# SEDGWICK COUNTY

Re: Final Plat S/D 87-97 - THE COURTS II

STAFF REPORT  
(Final Plat; Revised Preliminary Approved 10/8/87)

CASE NUMBER: S/D 87-97 - THE COURTS II

# FINAL PLAT OF THE COURTS II

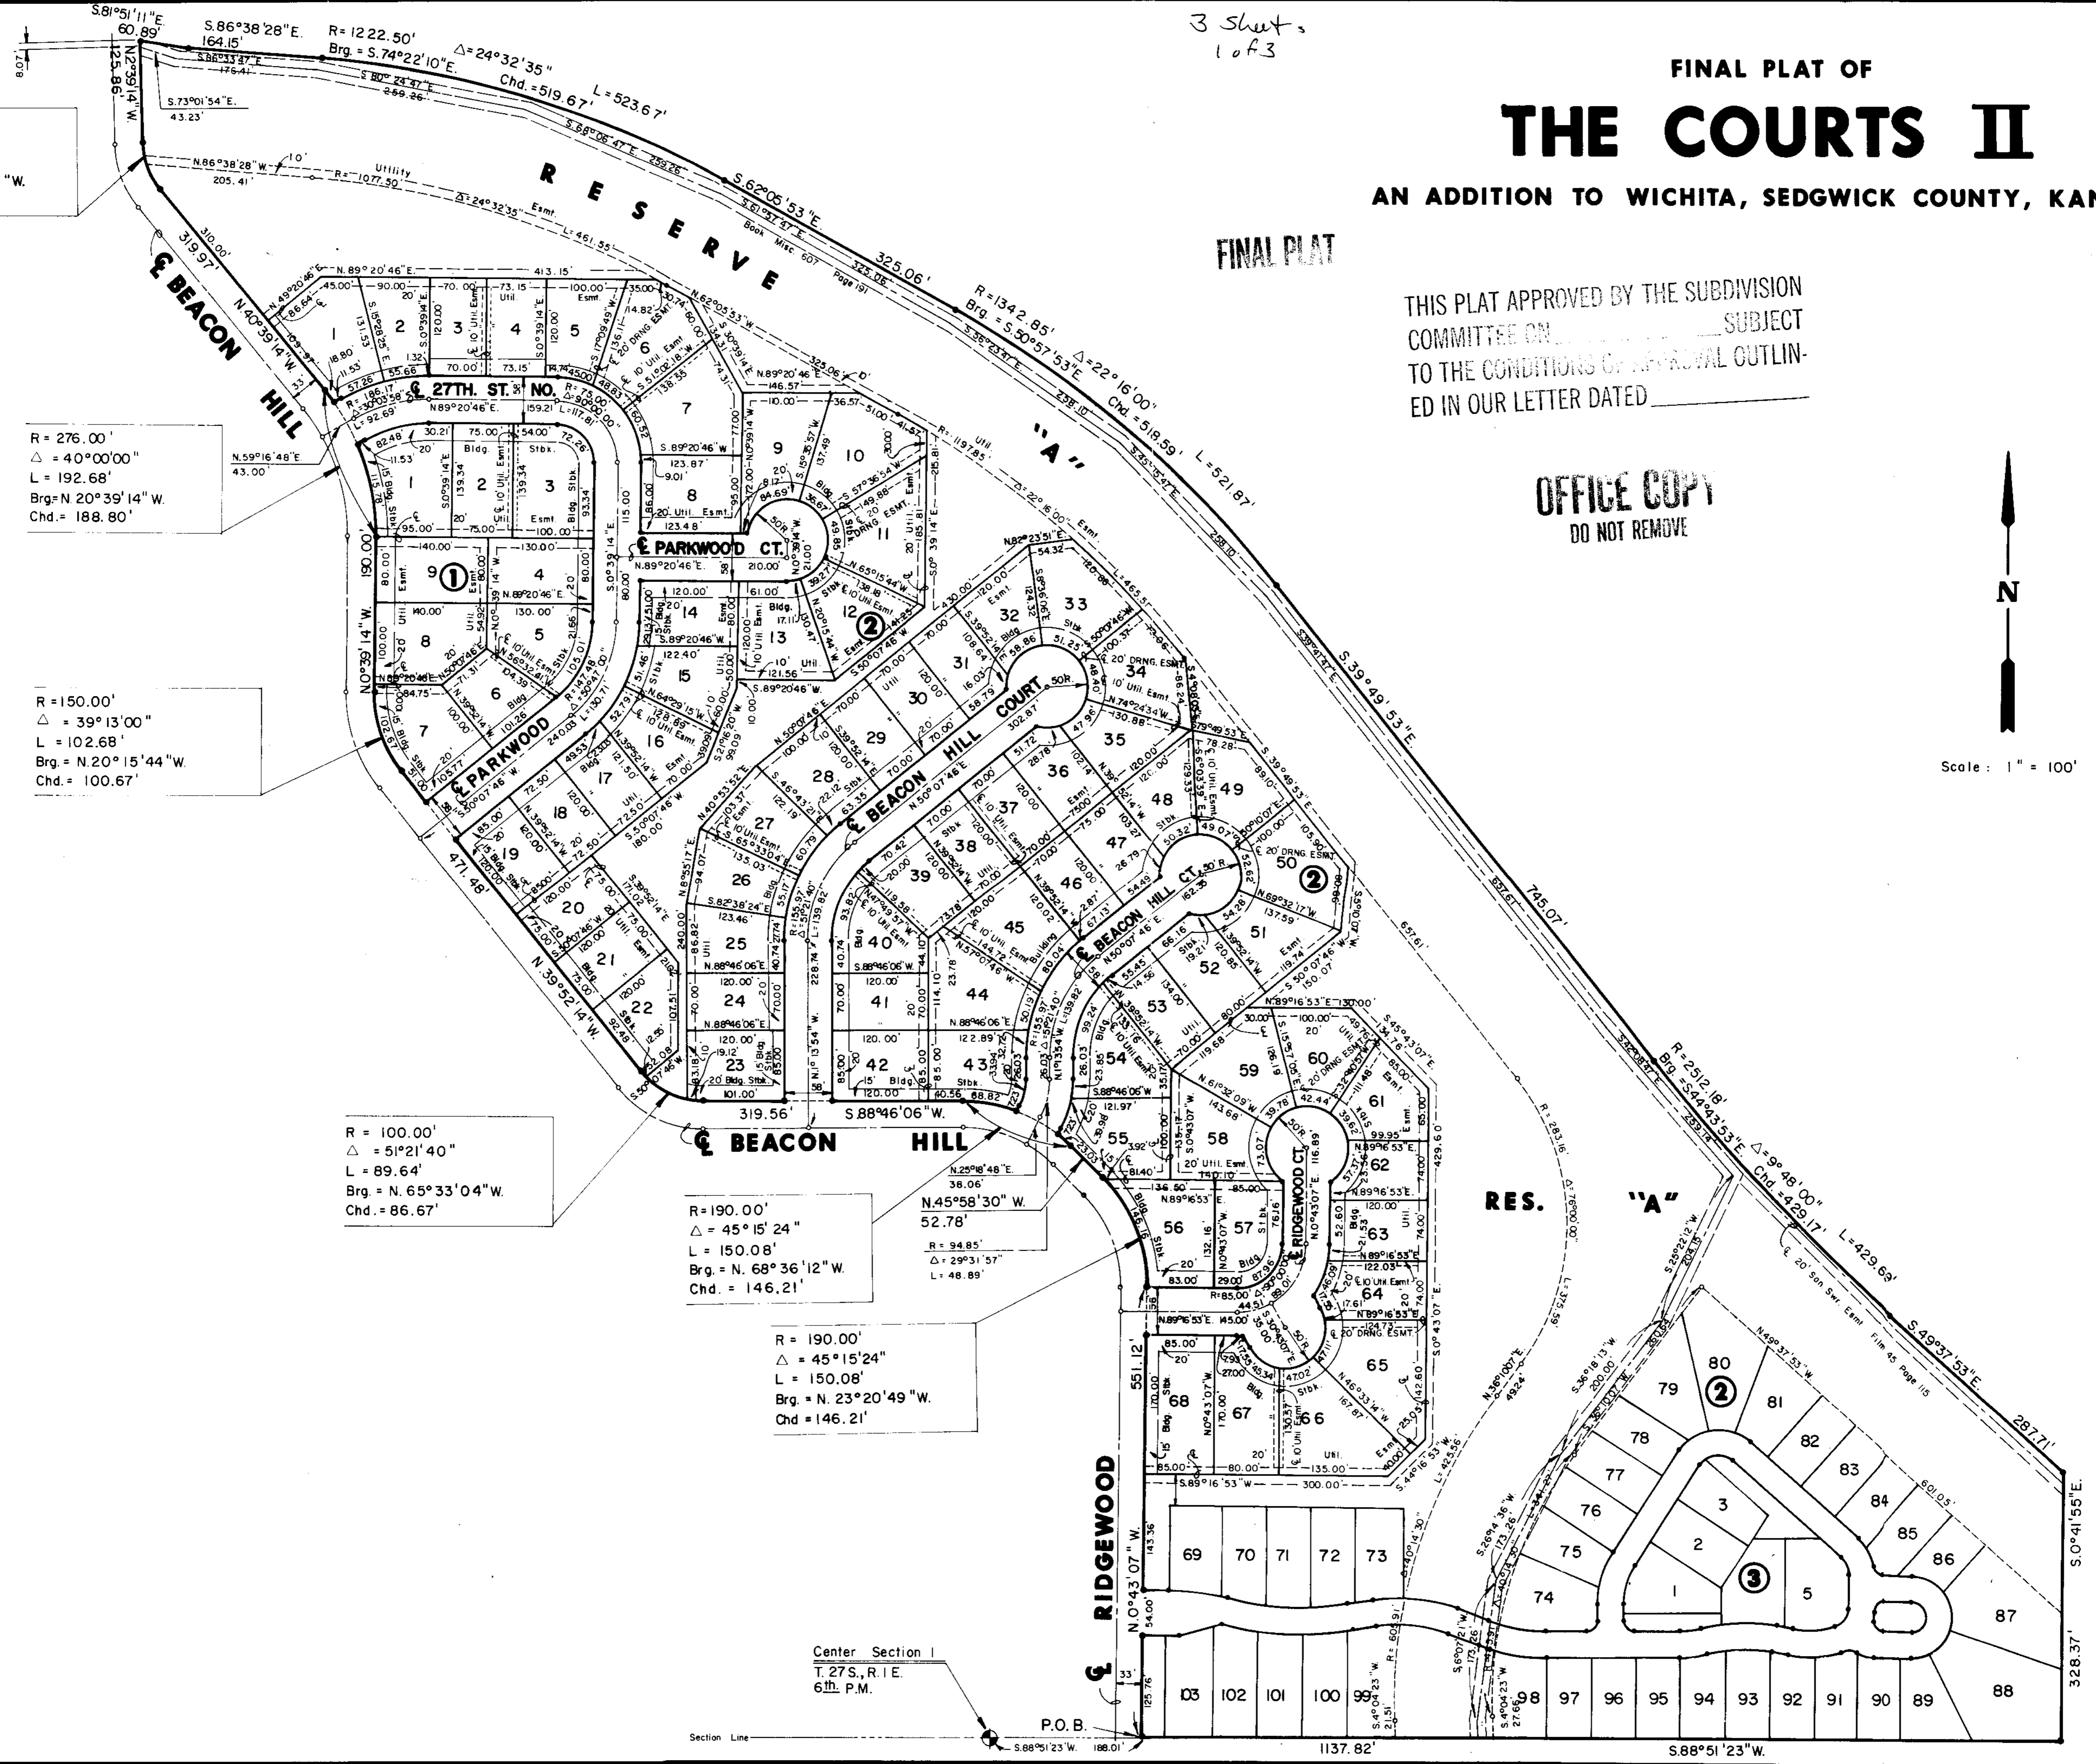
- U. The approved preliminary plat correctly depicted 25-foot front yard setbacks from Beacon Hill/Ridgewood (collector street). The affected lots are Lots 8 and 9, Block 1 and Lots 20, 21 and 22, Block 2. The final plat tracing shall indicate the platting of the 25-foot front yard setbacks that are required from the collector street.

- V. On the final plat tracing, the platlor's text shall be amended to reference the platting of "complete access control except for an emergency access point" to Edgemoor Drive across the south line of the plat.

- K. In order to provide a second means of emergency access to the lots east of the drainage channel in the southeast corner of this subdivision, the final plat tracing shall indicate the platting of an "emergency access easement" to connect Pembroke Circle with Edgemoor Drive. It is suggested that the perimeter of Reserve A be expanded to include the emergency access easement.

- P. On the final plat tracing, Edgemoor Drive to the south of this plat, shall be depicted.
- Q. On the face of the final plat tracing, the 10-foot "pedestrian access easement", which is centered on Lot 11 and 12's common lot line in Block 2, shall be labeled. The plat's text shall be amended to reference the platting of this easement. This easement, and the future sidewalk in the easement, are requirements of the approved sidewalk plan for this subdivision.

- R. On the final plat tracing, the plat's text shall be amended to state the purposes for which the reserves are being platted. The preliminary plat listed the desired uses and purposes of the reserves.

- S. On the final plat tracing, the plat's text shall be amended to reference the platting of the "parking easements" in Reserves D, E and F.

RESERVE "B" DETAIL

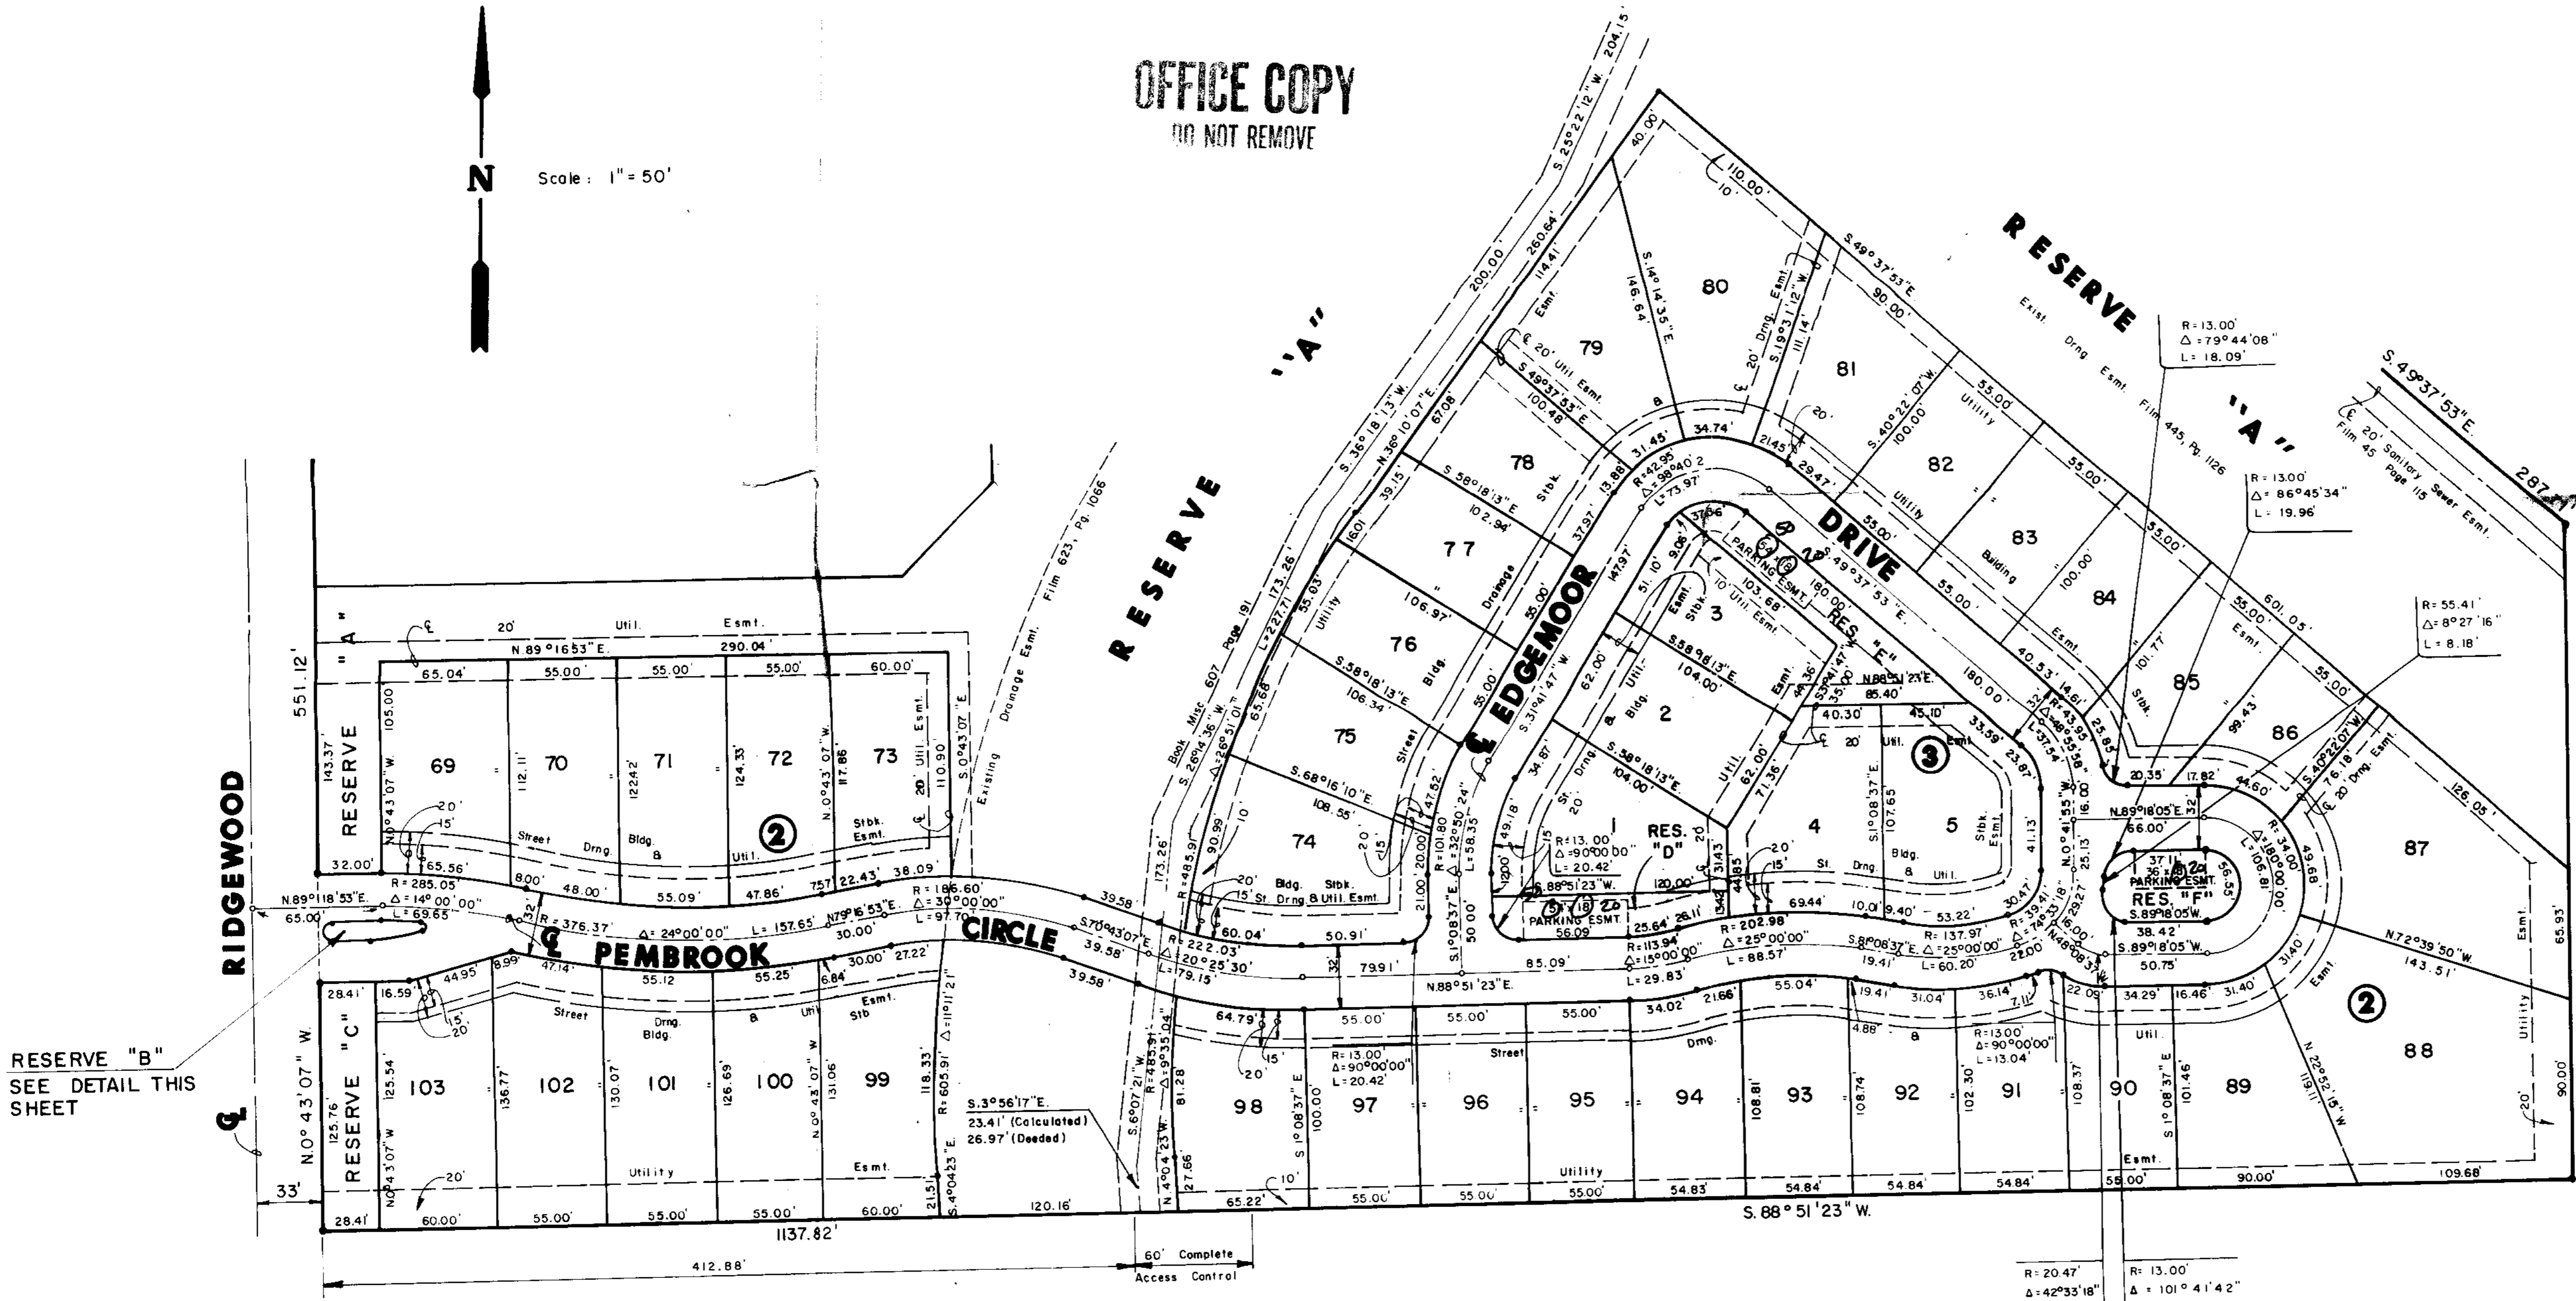
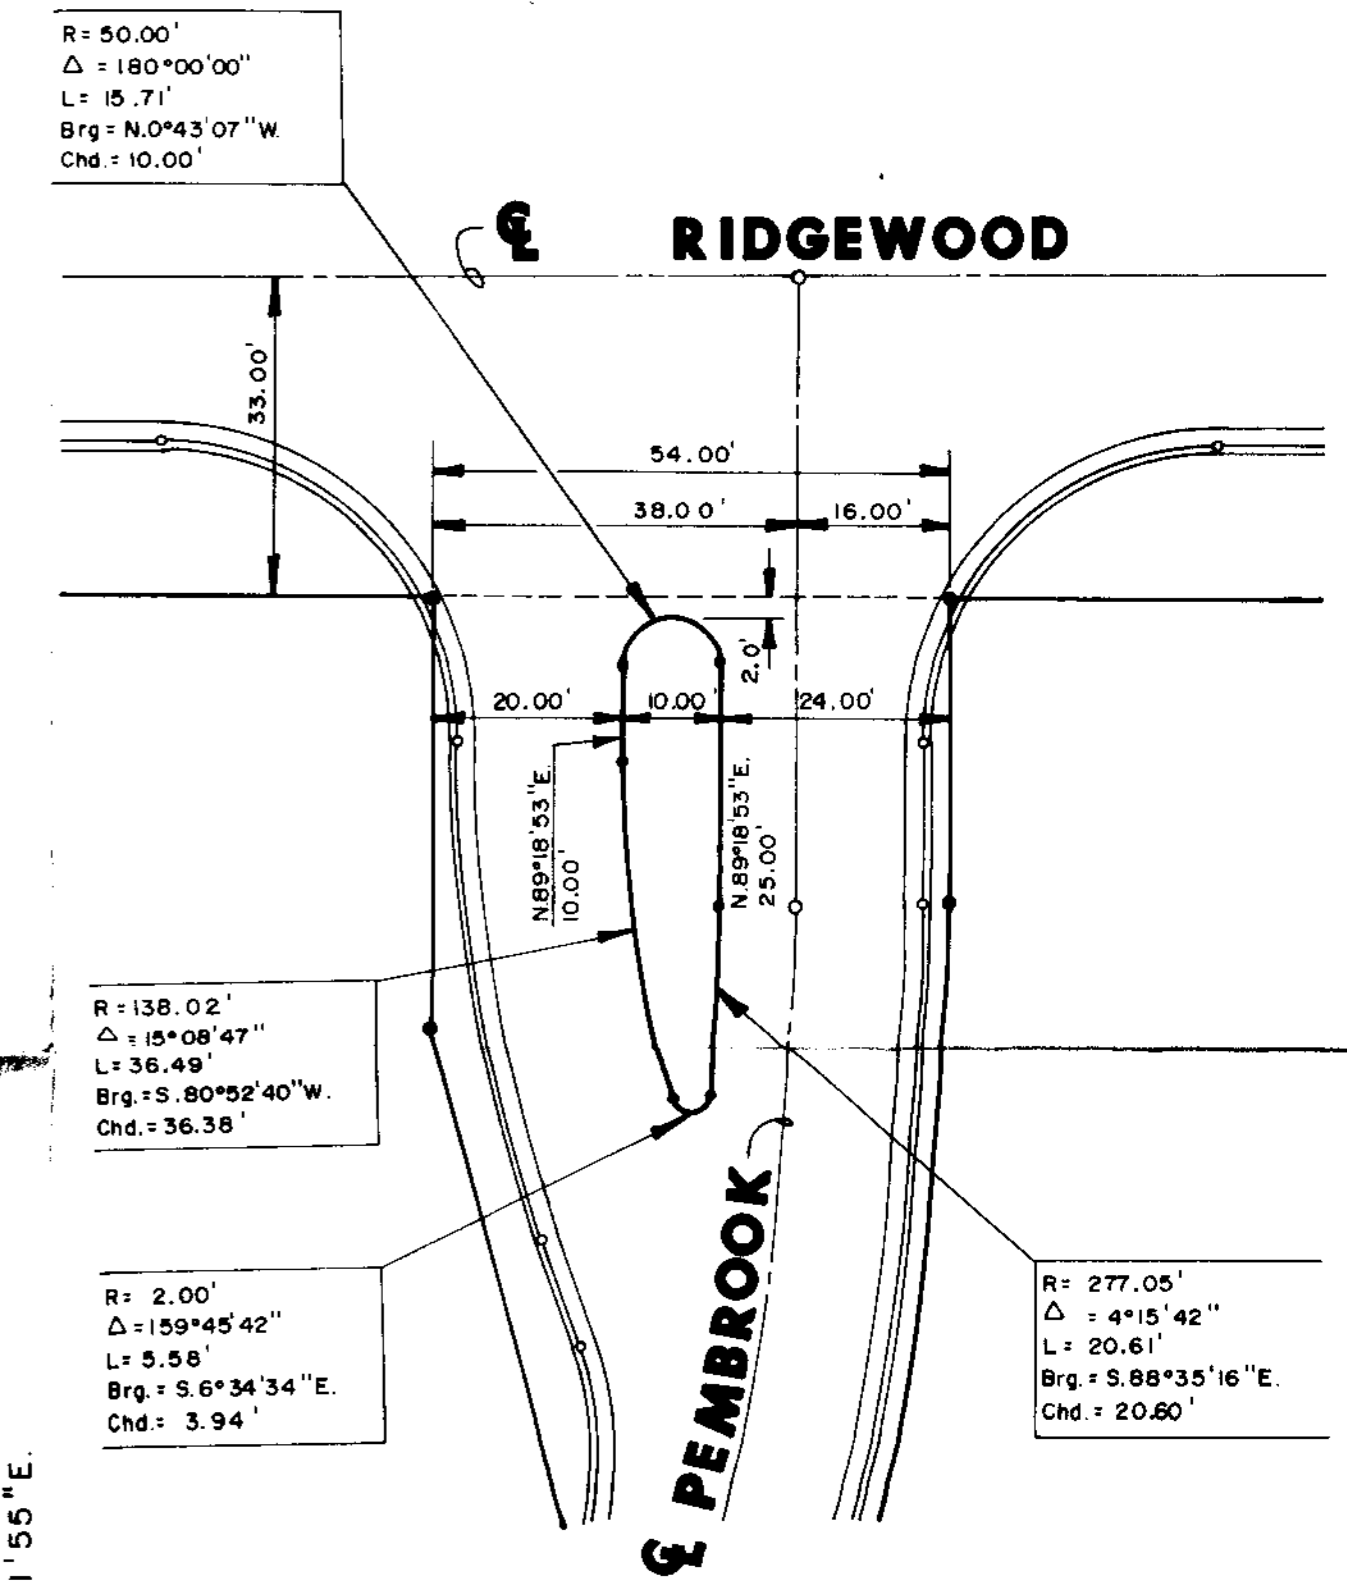
- T. Policy Statement No. 13 (Back Out Parking in Residential Areas) was adopted by the M.A.P.C. on November 13, 1986. This policy statement set the guidelines and rules for providing back out parking onto public and private streets. The policy statement requires parking easements to a minimum of 20 feet deep and have no more than 45 to 50 feet of street frontage. With these required dimensions in mind, the perimeters of the parking easements shall be redrawn to comply with the requirements of Policy Statement No. 13.
